## **DRAWINGS**

## **REMARKS**

REPLACEMENT SHEET (marked-up)

Fig.1.

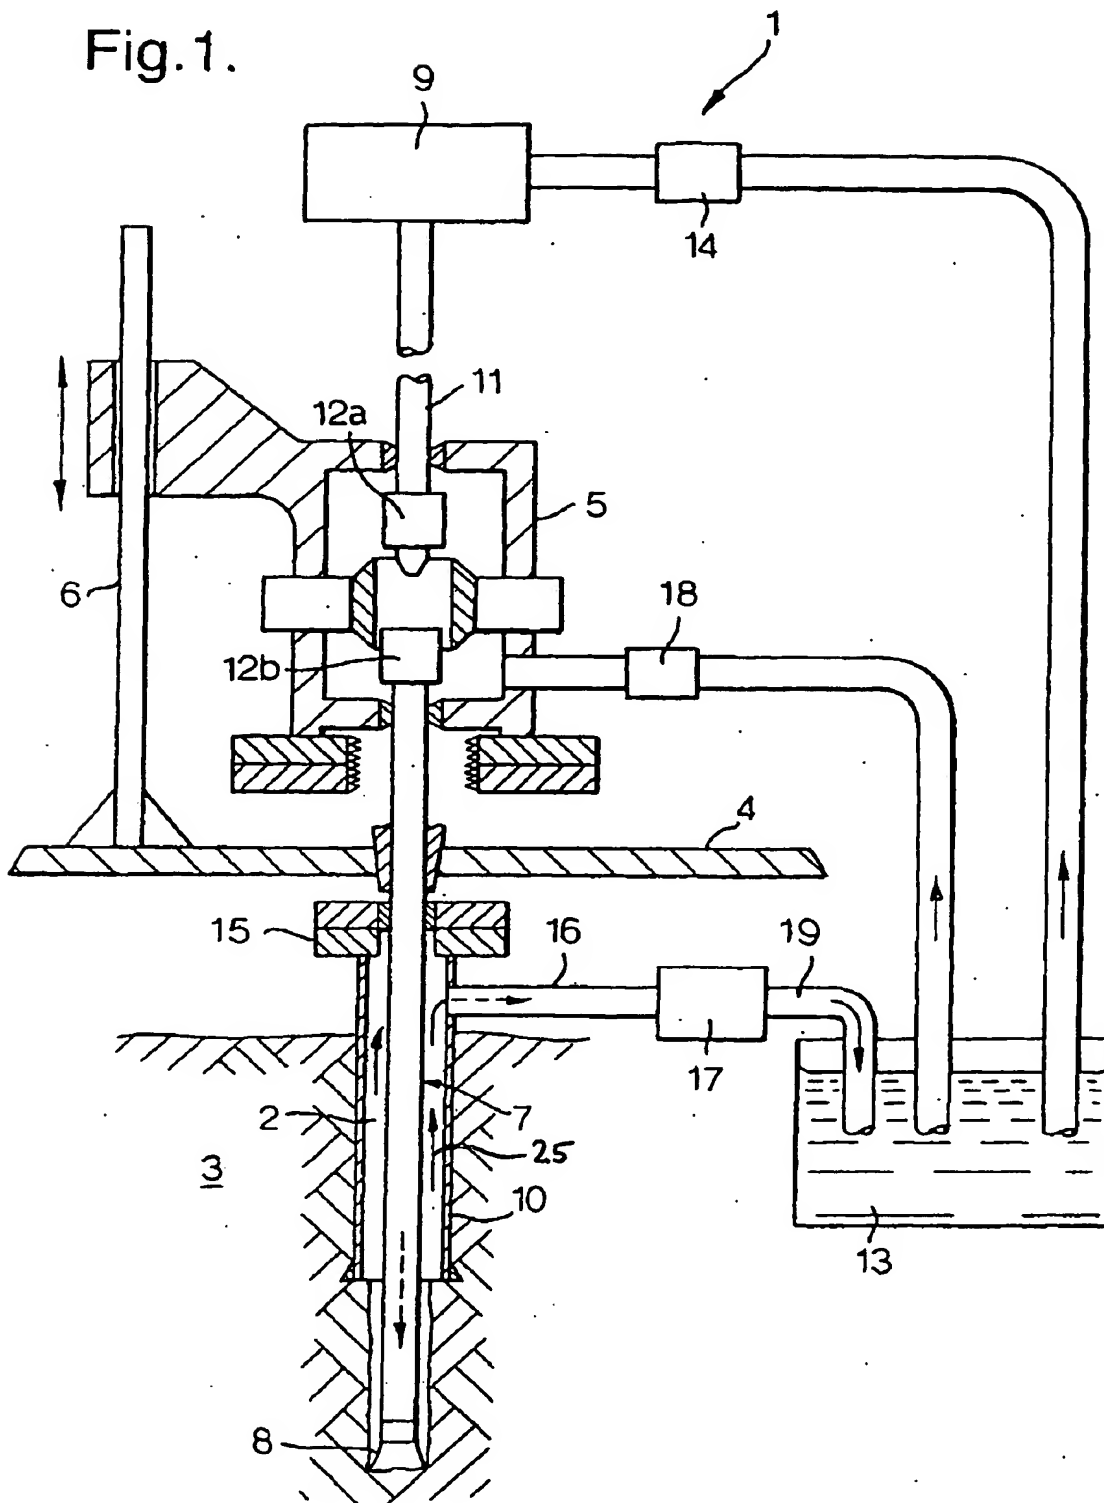
The Office Action objects to the drawings as failing to comply with 37 CFR 1.84(p)(4) because reference character "10" has been used to designate both casing (Fig. 1) and mud.

Attorney respectfully submits that reference character "10" only appeared once in the drawings. Hence, it is suggested that the objection made in the Office Action is essentially an objection against the specification which indeed uses in [0029] the reference character "10" to designate both casing and drilling mud.

To overcome any ground of objection, Attorney for Applicant herewith respectfully submits a replacement sheet containing amended Fig. 1 wherein a new reference sign "25" has been used to indicate the upwardly flowing drilling mud as specified in lines 9-11 of [0029].

It is respectfully submitted that the inclusion of the reference signs do not constitute addition of matter, because the lines 9-11 of [0029] in the specification leave no doubt that the drilling mud is flowing upwards into the annulus between the well bore wall and the drill string 7, corresponding to the arrow that originally appears in Fig. 1.

Fig.2.

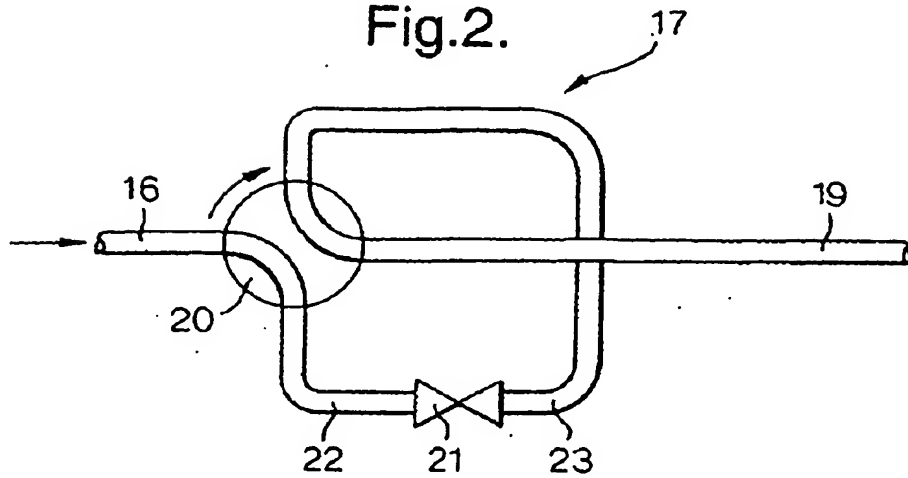
The Office Action also objects to the drawings as failing to comply with 37 CFR 1.84(p)(5), because they are found not to include reference sign "30" mentioned in [0032] of the specification.

This objection has been overcome by amendment of Fig. 3 to include reference sign "30" in the same way as reference sign "17" in Fig. 2. No matter has been added.
